Staff Report

To: BOZAR
From: Jessie Earley, Senior Planner
Meeting Date: DRC, January 12, 2025
RE: 45 Augusta Drive, Secondary Review

PROJECT TITLE: Augusta Park Partners LLC (45 Augusta Drive)

SUMMARY: Consideration of the application of **Augusta Park Partners LLC** to site a single family residence and a cold accessory building to be located at 45 Augusta Drive, Lot T5, Slate River Subdivision in the R1F zone.

Proposed Site plan

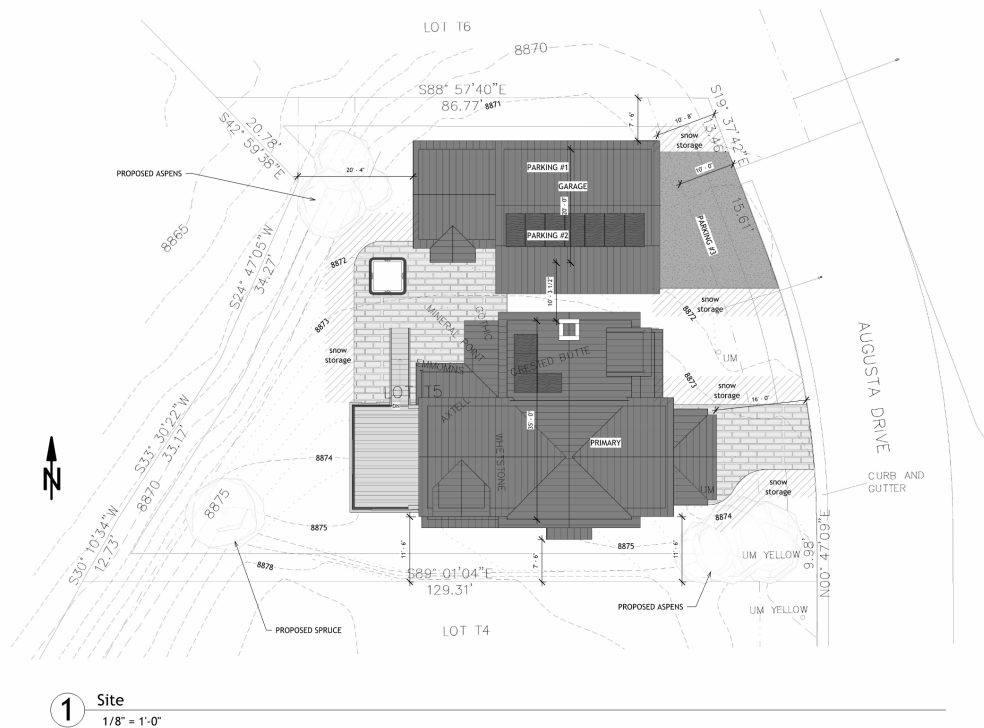
GL	Staff Analysis	DRC Recommendation
Topography	On the southwest corner of the lot the grade is noted as 8870'. This transitions to 8876' on the eastern portion of the lot. Over the course of the primary building footprint, the grade is 8875'9", which is the elevation used for measuring FAR. For the purposes of measuring FAR for the accessory building, the grade is 8872'.	
2.8 Drainage	Drainage information has not been provided. Drainage arrows for the site must be shown.	Add information to the site plan
Easements	There is a 10' utility easement for the east and west side of the lot. This must be called out on the site plan.	Add information to the site plan
2.16 Substantial landscaping	The plan is fairly minimal. Provision of

a final landscape plan will be required for review and approval if revisions are proposed after permitting prior to a CO.	
2.19 New trees	There no trees noted, which does not appear to meet the intents of GL 2.19 a as it requires two trees and 4.28.	12/8 DRC: Two trees must be added to satisfy the requirements of this GL.

2.16 a./ 2.20 Native plantings	Ground cover is not noted. Native materials are encouraged by the GL.	Add information to plans.
2.16 e Pervious materials 2.28 e & f Parking substrate	Walkway, and patio (420 sf, 1046 sf) are not called out but appear to be pavers. There is an area for the driveway to the accessory that is not noted for material, but should be (496 sf). Board members can discuss whether these areas are consistent with other proposals. Parking spaces must be called out on the plans.	Support

(2.37-2.40)/ 16-17-40 Exterior Lighting	Lighting has not been identified and must be to ensure it is in compliance with the night sky ordinance.	Add information to plans
Solar 2.10	Panels are shown on the west elevation of the primary building and south elevation of the accessory building/garage. Support.	Support
Utilities	Wet and dry utility lines have not been included. The water tap looks to be on the east portion of the lot. A forced main will be required and this lot does not have the option to convert to a gravity fed system. Adjacent rights of way (alley, Pyramid Avenue and Augusta Drive) must be included to scale.	Add information to plans

Southeast perspective

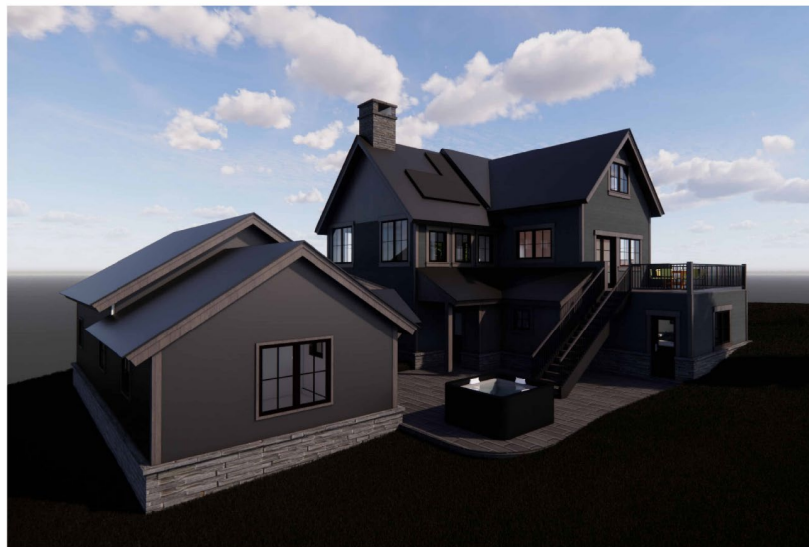
GL	Staff Analysis	DRC Recommendation
4.33-4.34	Consideration of whether the forms achieve relationships with historic buildings are in GL 4.33 and 4.34. 3D drawings are helpful to assess this.	Support
4.34 Discernable primary module	The front module, encouraged to be the discernable primary module appears to be met per GL4.34.	Support
